STAFF RECOMMENDATION

NCPC File No. 6759

WALTER REED NATIONAL MILITARY MEDICAL CENTER MEDICAL FACILITY ADDITIONS

Submitted by the United States Department of the Navy

BUILDING ELEVATIONS

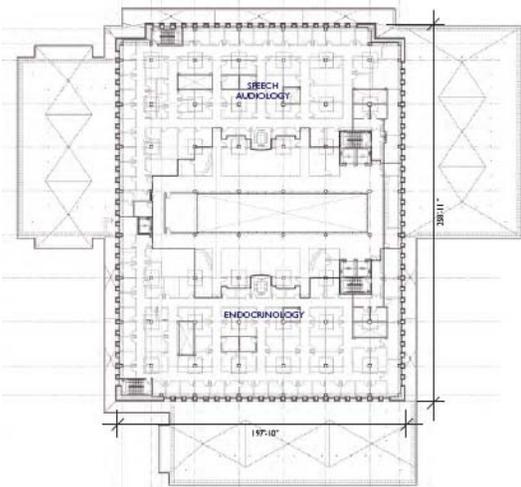
Comments favorably on the concept design for the new medical facility additions to the Walter Reed National Military Medical Center, Bethesda, with the exception of the fenestration pattern, as shown on NCPC Map File No. 3101.30(38.00)42383.

- Revised elevations indicating a more compatible fenestration pattern, and including dimensions and material notations.
- Information regarding the buildings' related site features, including lighting (proposed fixtures, locations, and foot-candle levels).

Staff requests that the applicant provide, with the preliminary site and building plans, revised elevations that include more compatible fenestration patterns; additional information with regard to the building's overall size and height; a more fully developed site and landscaping plan; and information on proposed exterior building/site lighting (including proposed fixtures, locations, and foot-candle levels). Information and samples of the proposed finish materials should also be submitted.
